Templemore N62 / L3220 / Mall Junction

Quality Audit Report

This report describes the Stage 1 Road Safety Audit carried out for the proposed infilling of the River Mall and associated road improvement works in the town of Templemore, County Tipperary. The site location is shown in *Error! Reference source not found.*, with the scheme running north - south crossing the N62 national road.

Figure 5-1 Proposed Streetscape Design at the Junction of the N62 and Blackcastle Road

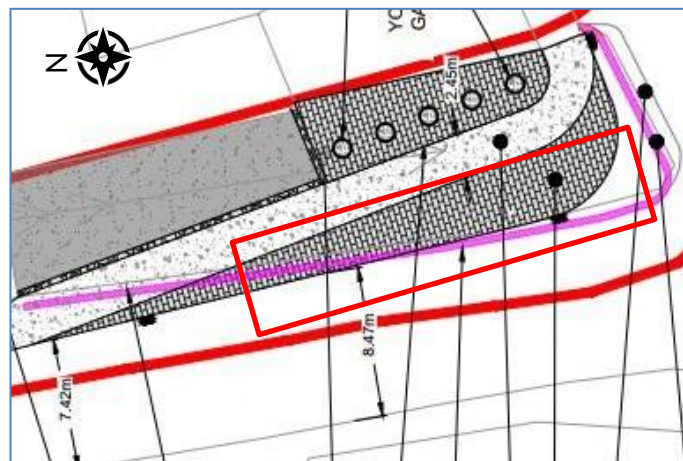
A streetscape area is proposed at the junction of the N62 with the Blackcastle Road within the infilled lands. The Audit Team are concerned the wide streetscape area may give rise to vehicles parking on it. This may result in potential conflicts with pedestrian and vehicles and also give rise to junction visibility issues leading to potential collisions at the junction.

The Design Team should provide appropriate measures to prevent vehicles parking on the paved area within the proposed design.

Figure 5-3 Proposed N62 / Blackcastle Road Junction Width

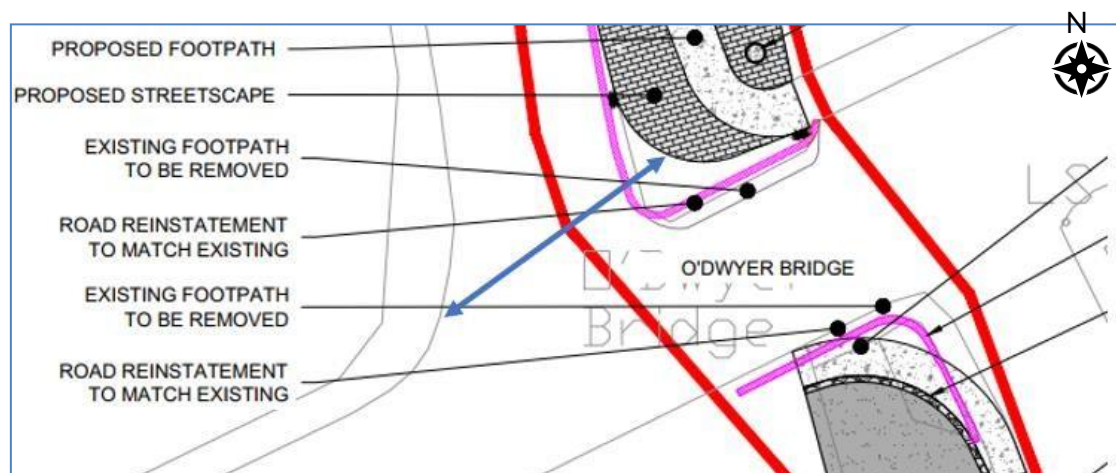
The proposed design shows work only to the eastern side of the N62 / Blackcastle Road junction. The existing wide corner radius on the west side of the junction, in conjunction with the increased eastern corner radius will potentially give rise to higher vehicle speeds turning at the junction. It will also result in increased pedestrian crossing times, which will increase the risk of collisions between motorised and non-motorised road users.

The Design Team should provide junction widths in accordance with guidance from the Design Manual for Urban Roads and Streets in accordance with the urban road speed.

Figure 5-4 Eastbound Approach to the N62 / Blackcastle Road / The Mall Junction

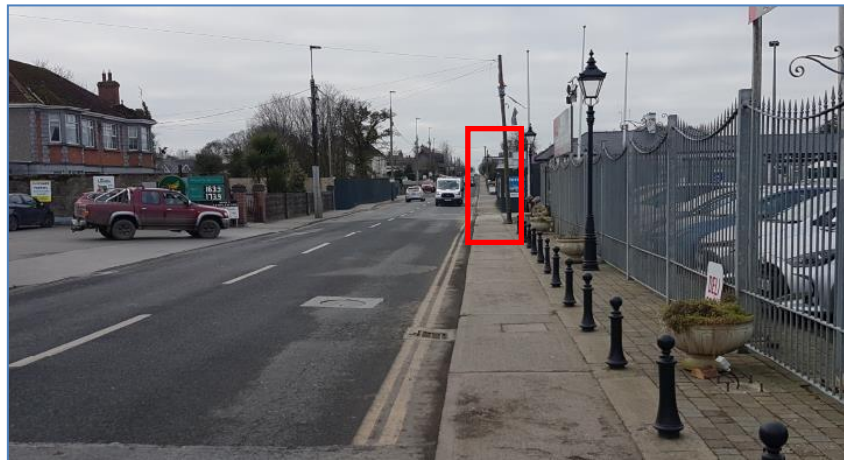
The Audit team observed onsite the presence of warning signage on the minor road approaches to the N62 staggered junction. Warning signage is being provided on the major road approaches

in both directions at quite a distance away from the junction. Significant distance of warning signage to hazards may result in lack of awareness of drivers, believing the warning signs are no longer valid to the area. This could give rise to head on collisions, turning collisions or rear end collisions at the junction as drivers may.

The Design Team should provide staggered junction warning signage on the major road at suitable distances from the hazard.

Figure 6-1 Proposed Streetscape Design at the Junction of the N62 and Blackcastle Road

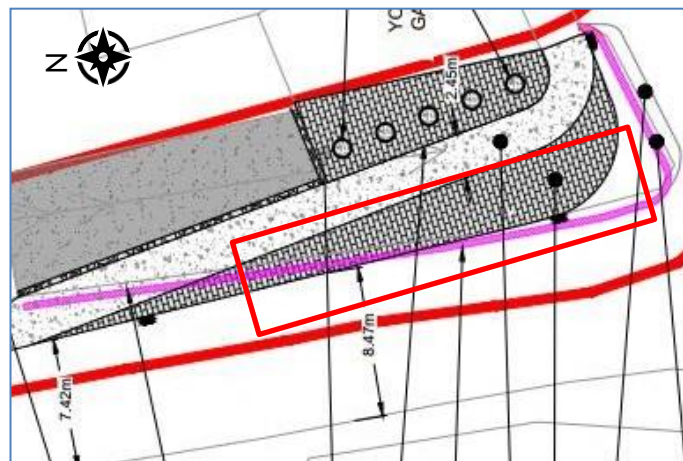
A streetscape area is proposed at the junction of the N62 with the Blackcastle Road within the infilled lands. The Audit Team are concerned the wide streetscape area may give rise to vehicles parking on it. This may result in potential conflicts with pedestrian and vehicles and also give rise to junction visibility issues leading to potential collisions at the junction.

The Design Team should provide appropriate measures to prevent vehicles parking on the paved area within the proposed design.

Figure 6-3 Proposed N62 / Blackcastle Road Junction Width

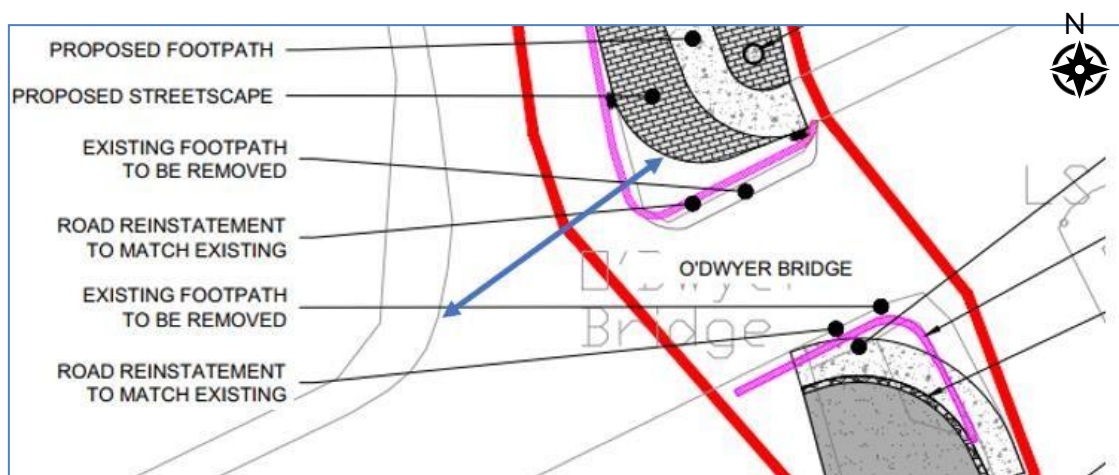
The proposed design shows work only to the eastern side of the N62 / Blackcastle Road junction. The existing wide corner radius on the west side of the junction, in conjunction with the increased eastern corner radius will potentially give rise to higher vehicle speeds turning at the junction. It will also result in increased pedestrian crossing times, which will increase the risk of collisions between motorised and non-motorised road users.

The Design Team should provide junction widths in accordance with guidance from the Design Manual for Urban Roads and Streets in accordance with the urban road speed.

Figure 6-5 Restricted Footway Width on Blackcastle Road adjacent to scheme

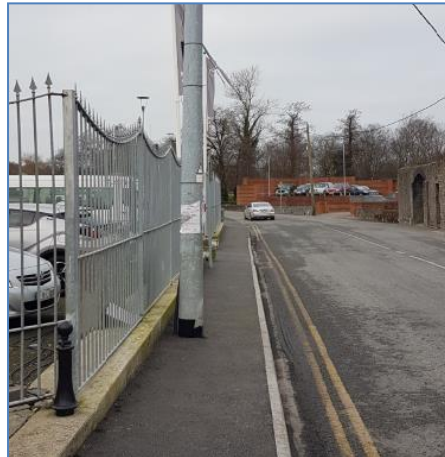
The Audit Team noted during the site visit that adjacent to the scheme are areas of restricted footpath widths due to temporary and permanent fixtures.

Figure 8-3 Drawing 11007-2014-D01 extract showing interface between road and proposed footway

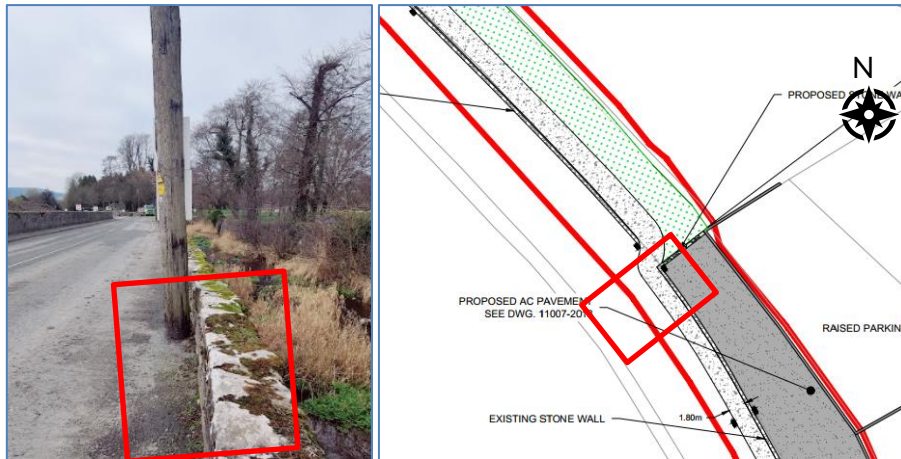
The footway alignment shifts from behind the culvert wall to online into the existing carriageway (i.e. abrupt change in alignment). The development of the footway occurs instantaneously in line of oncoming traffic without any proposed protection. Wall height may pose an issue to the visibility of small children while the sudden inclusion of a kerb without prior warning could present a significant safety hazard to drivers leading to both pedestrian and vehicular collisions.

Figure 8-4 Extract of Proposed Footway widths from preliminary design drawings

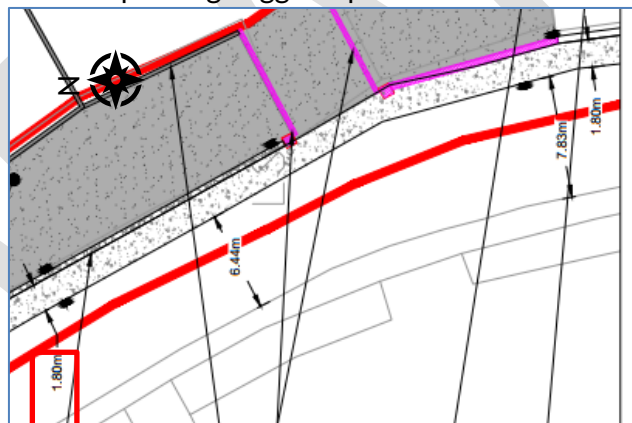
The audit team note that the proposed width is in line with the absolute minimum standard footway widths, potentially creating a passing hazard for pedestrians forcing them onto the existing carriageway creating a conflict point between vehicles and pedestrians, in particular for wheelchair users and those pushing buggies / prams.

Figure 8-6 Proposed Streetscape Design at the Junction of the N62 and Blackcastle Road

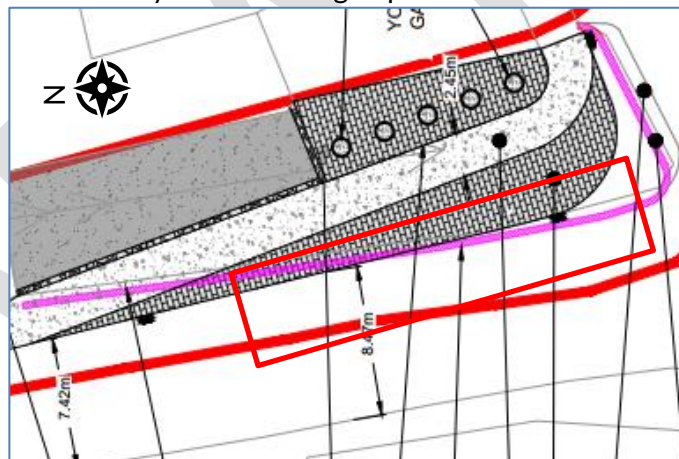
A streetscape area is proposed at the junction of the N62 with the Blackcastle Road within the infilled lands. The Audit Team are concerned the wide streetscape area may give rise to vehicles parking on it. This may result in potential conflicts with pedestrian and vehicles and also give rise to junction visibility issues leading to potential collisions at the junction.

The Design Team should provide appropriate measures to prevent vehicles parking on the paved area within the proposed design.

Figure 8-8 Proposed N62 / Blackcastle Road Junction Width

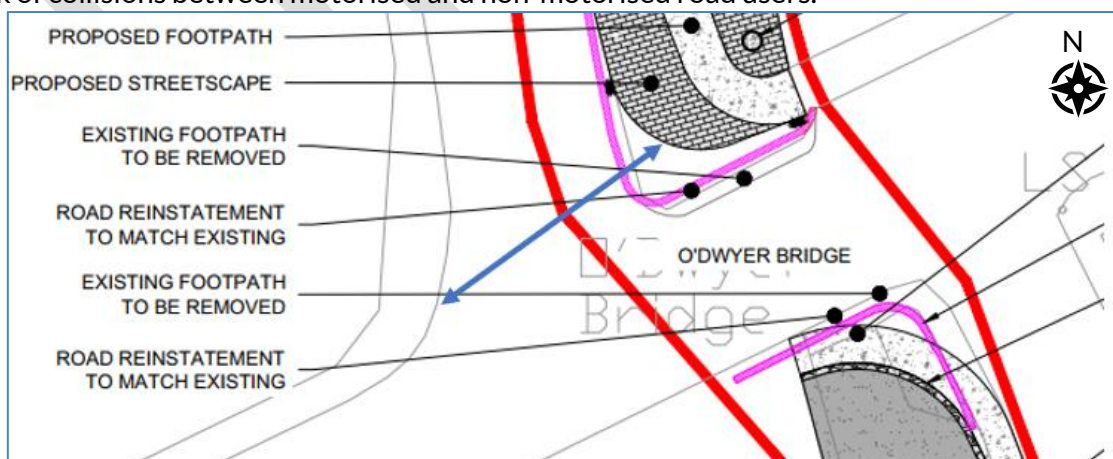
The proposed design shows work only to the eastern side of the N62 / Blackcastle Road junction. The existing wide corner radius on the west side of the junction, in conjunction with the increased eastern corner radius will potentially give rise to higher vehicle speeds turning at the junction. It will also result in increased pedestrian crossing times, which will increase the risk of collisions between motorised and non-motorised road users.

The Design Team should provide junction widths in accordance with guidance from the Design Manual for Urban Roads and Streets in accordance with the urban road speed.

Figure 8-9 Eastbound Approach to the N62 / Blackcastle Road / The Mall Junction

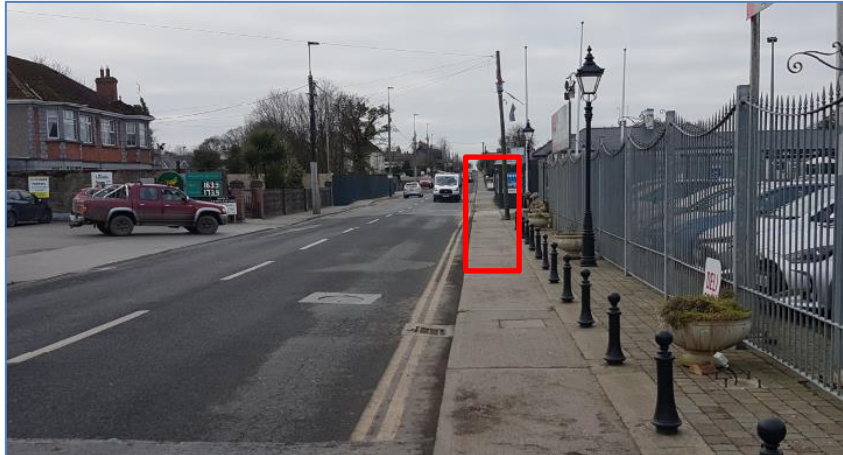
The Audit team observed onsite the presence of warning signage on the minor road approaches to the N62 staggered junction. Warning signage is being provided on the major road approaches in both directions at quite a distance away from the junction. Significant distance of warning signage to hazards may result in lack of awareness of drivers, believing the warning signs are no longer valid to the area. This could give rise to head on collisions, turning collisions or rear end collisions at the junction as drivers may.

The Design Team should provide staggered junction warning signage on the major road at suitable distances from the hazard.

Figure 8-12 Interface of proposed footway and existing footway alignment

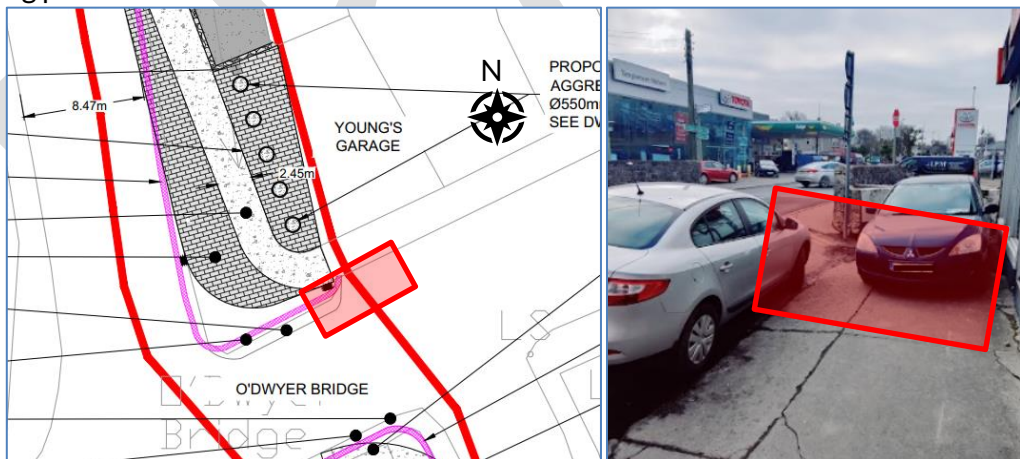
The Audit Team observed parking to the east of the N62 / Blackcastle Road junction fronting Young's Garage. The proposed footway alignment tying into the existing footway, may overlap with this area, displacing vehicles resulting in vehicles parked in closer proximity to the junction negatively impacting on visibility. Or vehicles parked on the proposed footway impeding pedestrians.

Figure 8-13 Existing Stone Wall Condition and Proposed Works

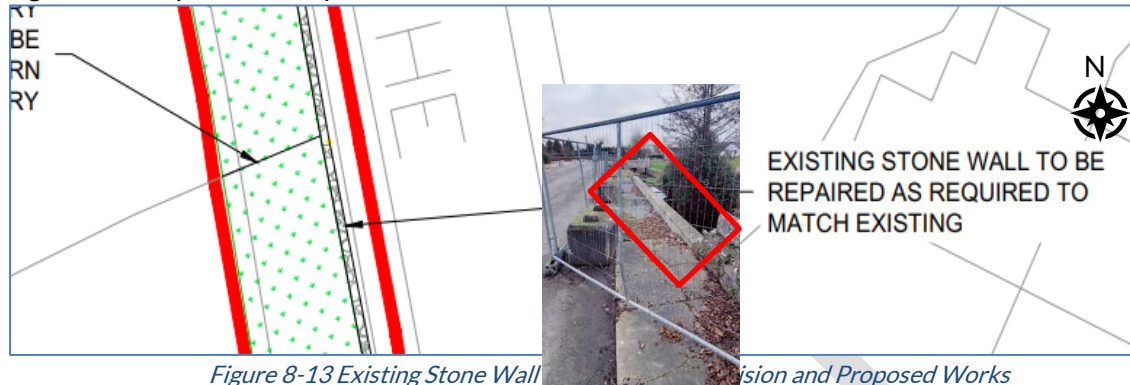
The Audit Team observed along The Mall Road, the existing footway and culvert wall has been significantly damaged with proposed design noting that *“the existing stone wall to be repaired as required to match existing”*. Retention of the existing footway in the current state is a significant trip hazard to pedestrians.

Figure 26-1 Restricted Footway Width on Blackcastle Road adjacent to scheme

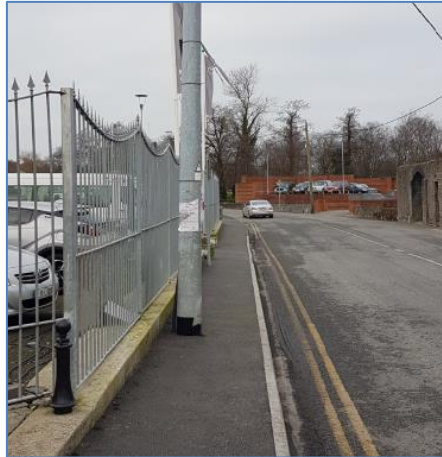
The Road Safety Audit Team noted during the site visit that adjacent to the scheme are areas of restricted footpath widths due to temporary and permanent fixtures.

Figure 2-1 Proposed Streetscape Design at the Junction of the N62 and Blackcastle Road

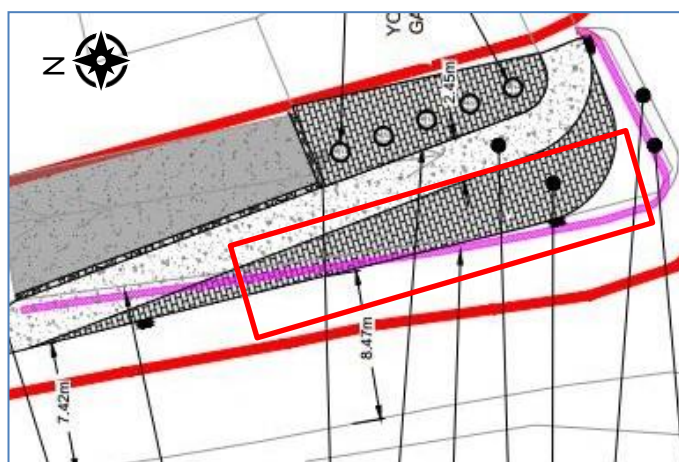
A streetscape area is proposed at the junction of the N62 with the Blackcastle Road within the infilled lands. The Audit Team are concerned the wide streetscape area may give rise to vehicles parking on it. This may result in potential conflicts with pedestrian and vehicles and also give rise to junction visibility issues leading to potential collisions at the junction.

The Design Team should provide appropriate measures to prevent vehicles parking on the paved area within the proposed design.

Figure 2-3 Proposed N62 / Blackcastle Road Junction Width

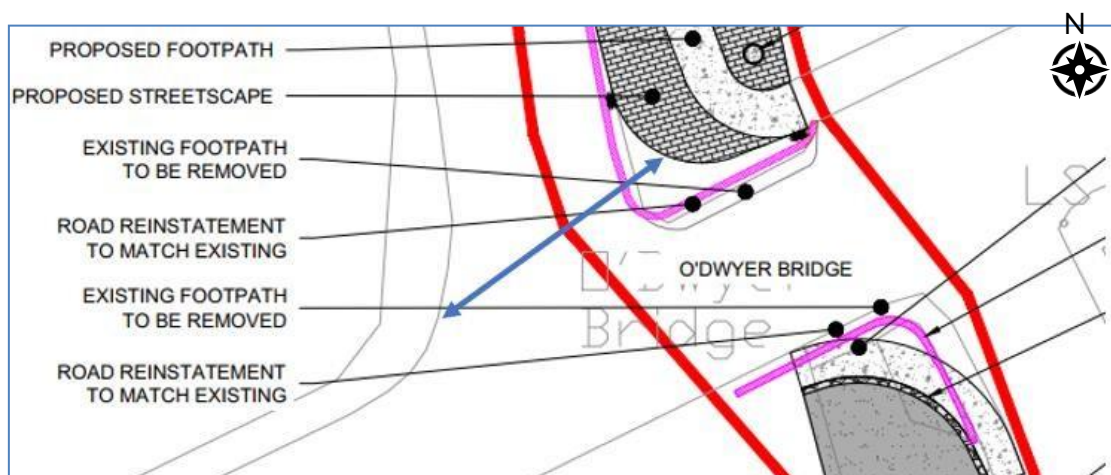
The proposed design shows work only to the eastern side of the N62 / Blackcastle Road junction. The existing wide corner radius on the west side of the junction, in conjunction with the increased eastern corner radius will potentially give rise to higher vehicle speeds turning at the junction. It will also result in increased pedestrian crossing times, which will increase the risk of collisions between motorised and non-motorised road users.

The Design Team should provide junction widths in accordance with guidance from the Design Manual for Urban Roads and Streets in accordance with the urban road speed.

Figure 2-4 Interface of proposed footway and existing footway alignment

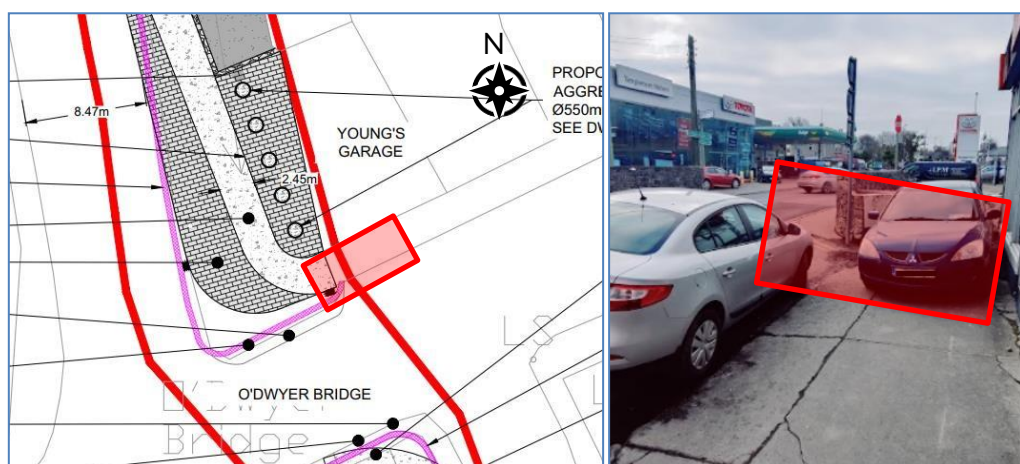
The Audit Team observed parking to the east of the N62 / Blackcastle Road junction fronting Young's Garage. The proposed footway alignment tying into the existing footway, may overlap with this area, displacing vehicles resulting in vehicles parked in closer proximity to the junction negatively impacting on visibility. Or vehicles parked on the proposed footway impeding pedestrians.

Figure 2-5 Restricted Footway Width on Blackcastle Road adjacent to scheme

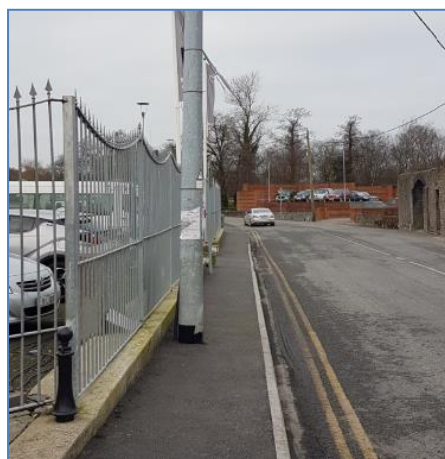
The Audit Team noted during the site visit that adjacent to the scheme are areas of restricted footpath widths due to temporary and permanent fixtures.
